ANN ARBOR HISTORIC DISTRICT COMMISSION

Staff Report

ADDRESS: 618 South Ashley Street, Application Number HDC18-277

APPLICATION: The applicant seeks HDC approval to: construct a gabled wall dormer on the south roof face; install two skylights on the north roof; construct a second-floor deck off the back of the house; replace the rear elevation attic window with a larger one from the second floor; and install a full-lite wood door in place of the second floor window, leading to the new deck.

3 WEST ELEVATION-PROPOSED

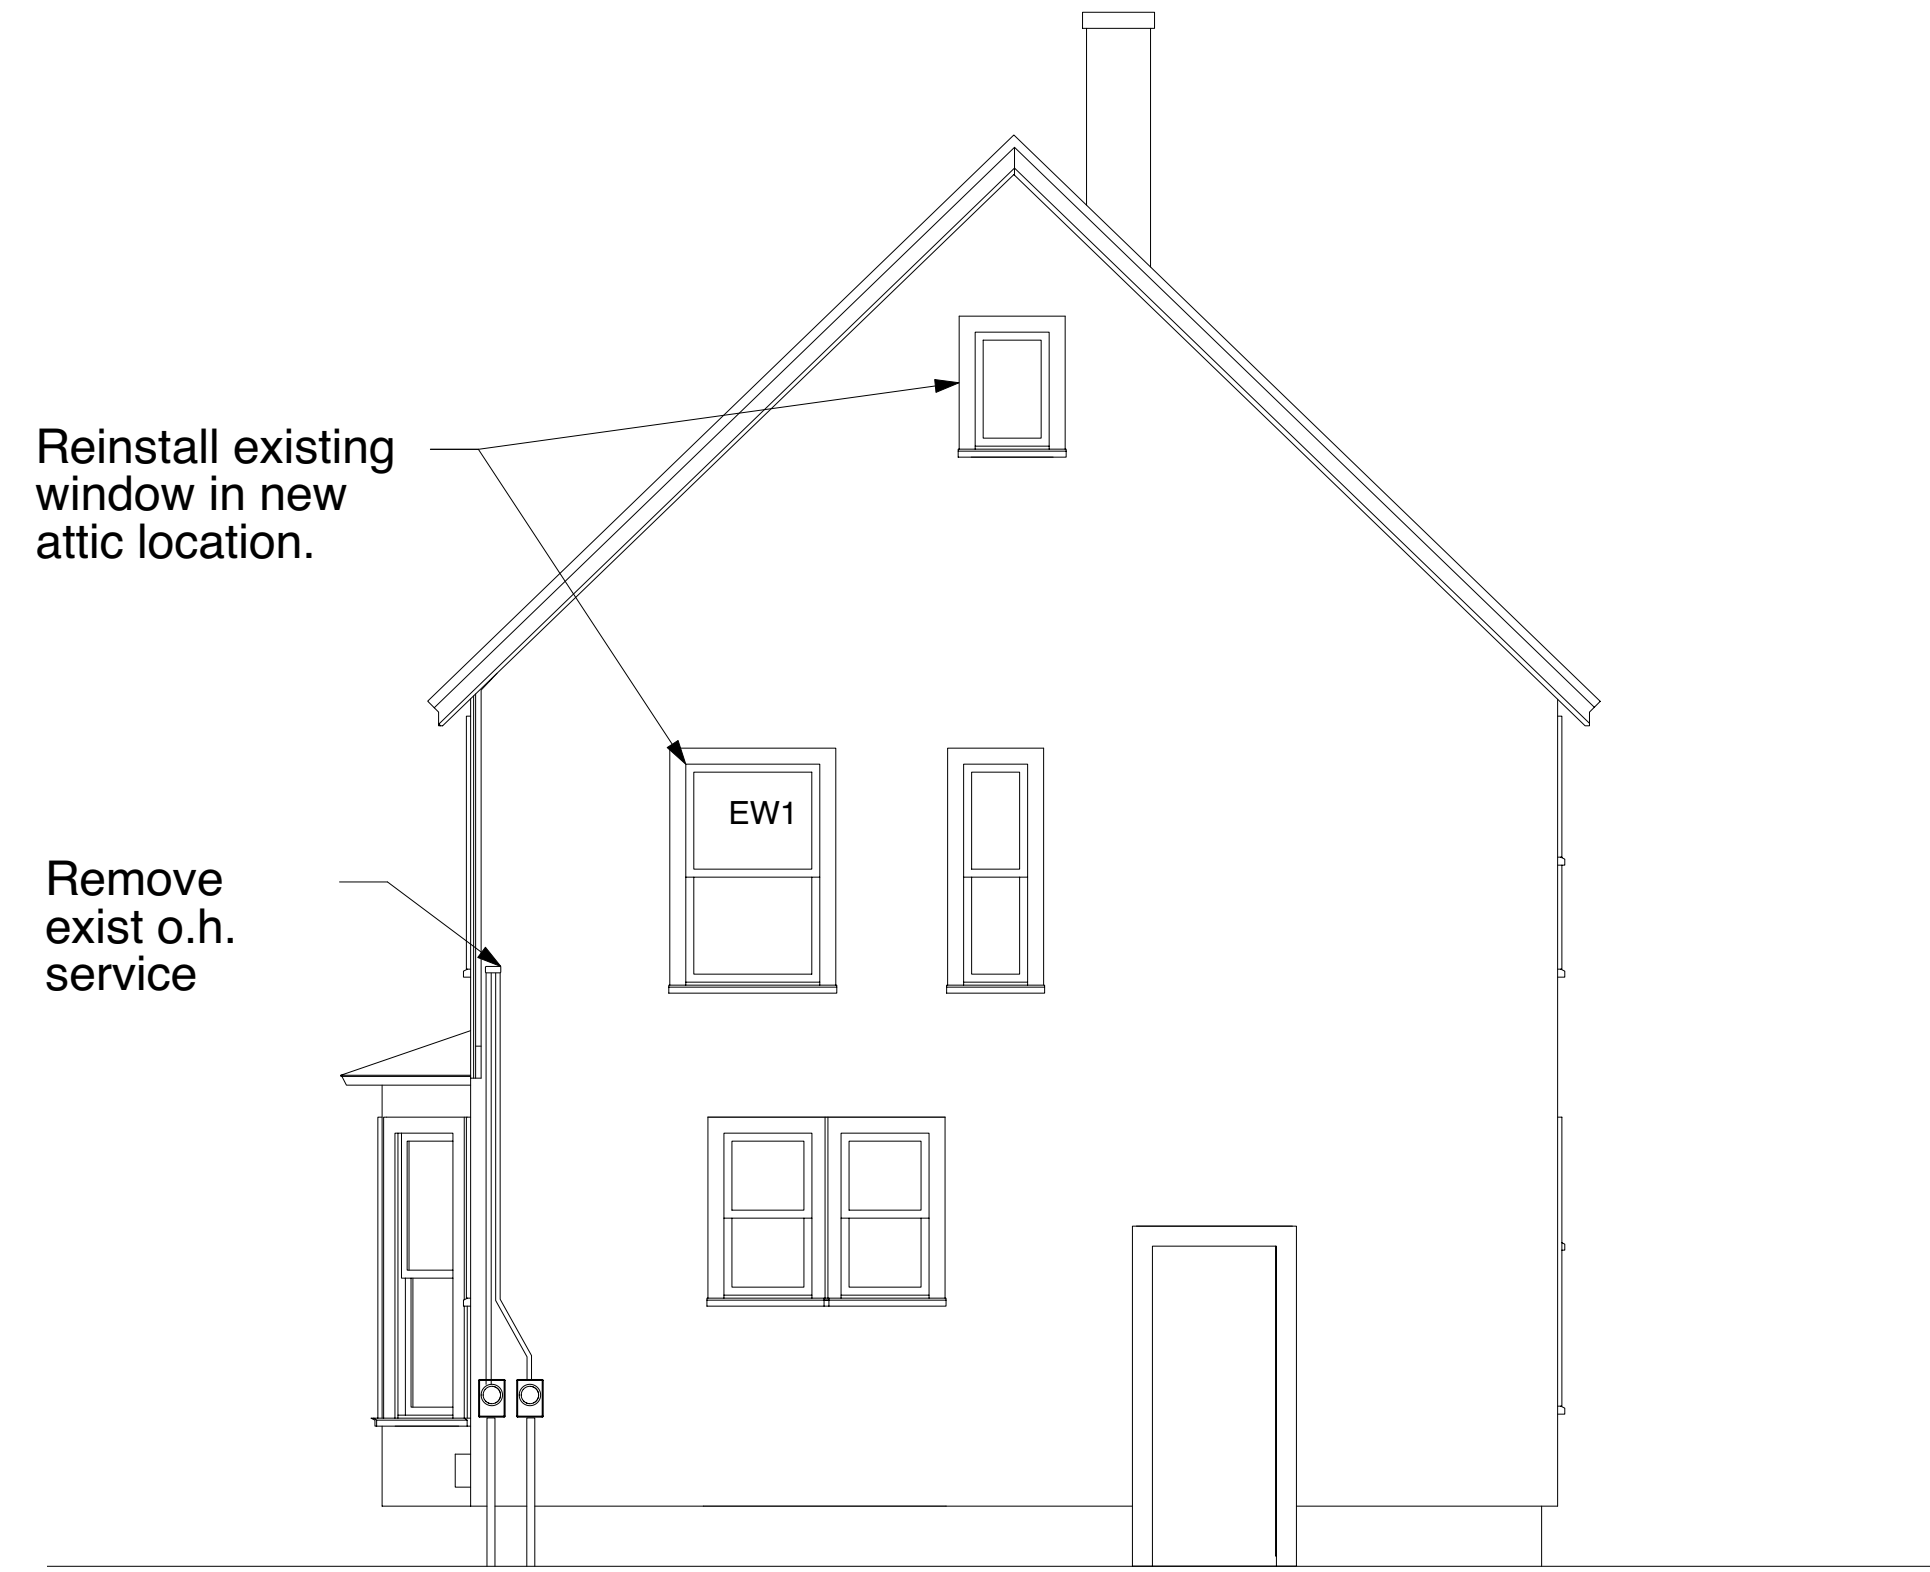
2. On the rear elevation (west), a second floor kitchen window is proposed to be enlarged into a full-lite door that maintains the window's original 36" width. The double-hung window would be moved to the attic gable to replace a small fixed window and provide light and ventilation. The door would lead to a 12'6" wide by 8'4" deep composite deck off the second floor. The deck features a simple steel rod railing. Electrical and communications wires to the house would be buried.

2 SOUTH ELEVATION-PROPOSED

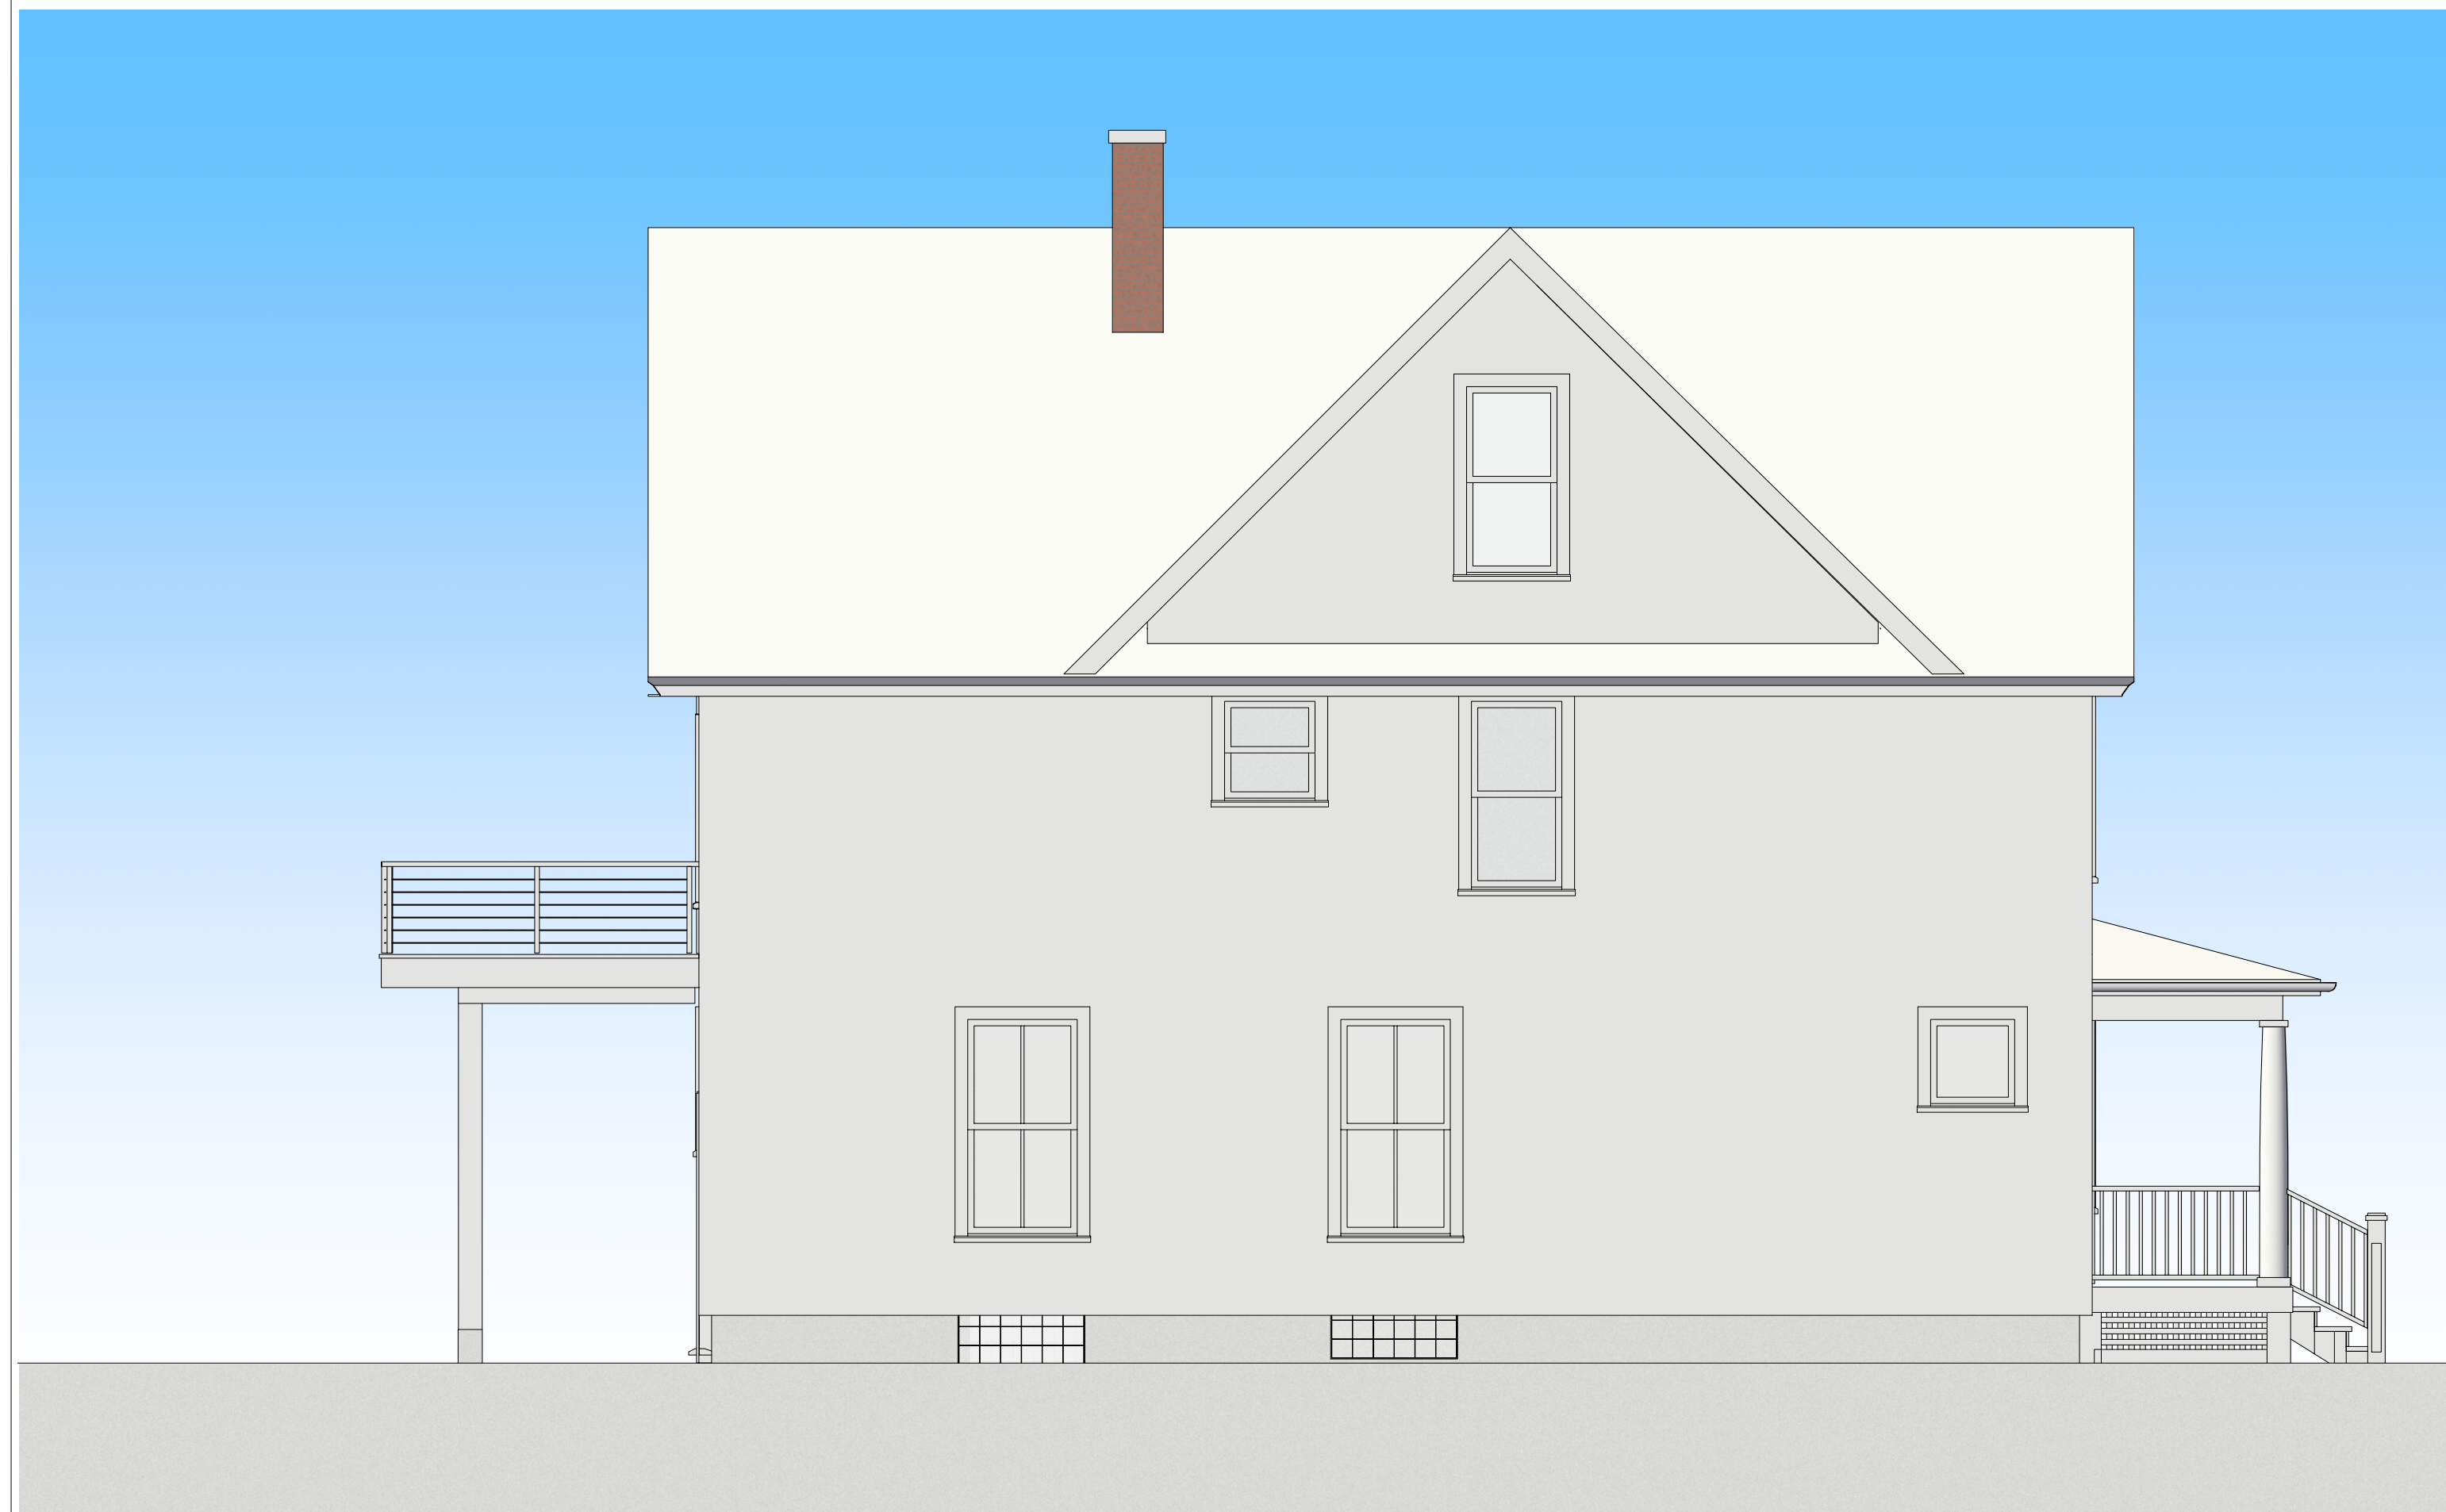
1. The house is an owner-occupied duplex, with a unit on the ground floor and another on the second floor. In order to finish the attic into habitable space, a dormer is necessary to gain adequate headroom for the attic stair. The design of the gable wall dormer is appropriate for this tall two-story house and is compatible with its historic character. A casement double-hung egress window, with compatible proportions to other windows on the house, is located in the dormer. Dormer cladding is 4" exposure cement board lap siding. Two skylights are proposed on the north side of the roof.
